LOWER GROUND FLOOR PLAN

Apple Brook House, Chadlington

Project W175	Sheet 27F
Date 09/01/2017	
Scale DO NOT SCALE

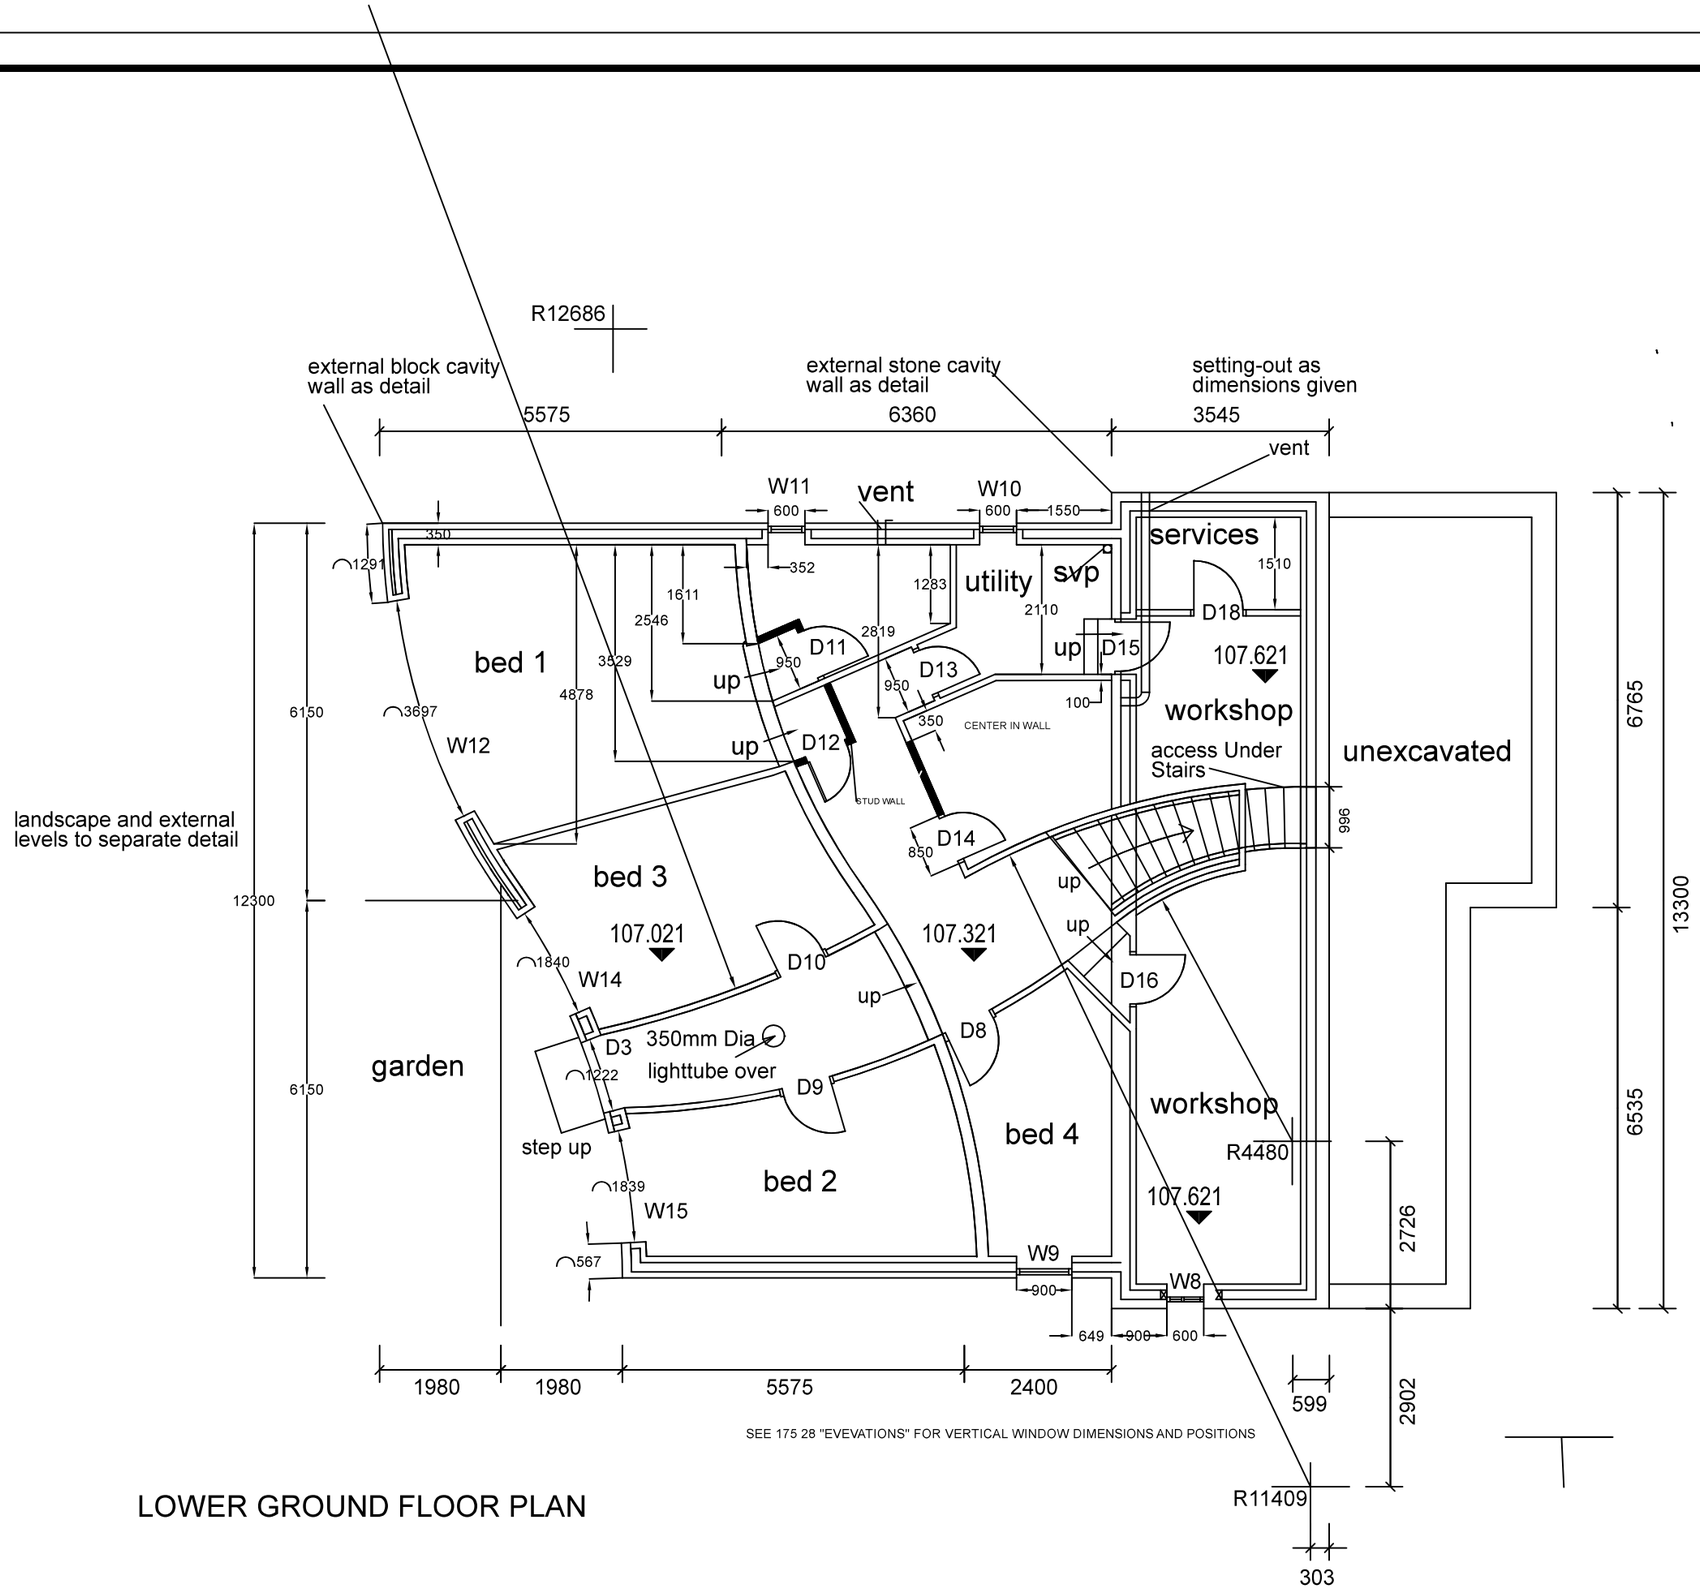
Rev E - Corrected 150mm block to 100 ext walls. Reduced W12 size. Added dimensions. Marked walls around D11 and D12 as stud. Renamed window from W12W13 to W12

Rev F - Window W8 changed from 800 to 600. Added stud wall in main bathroom
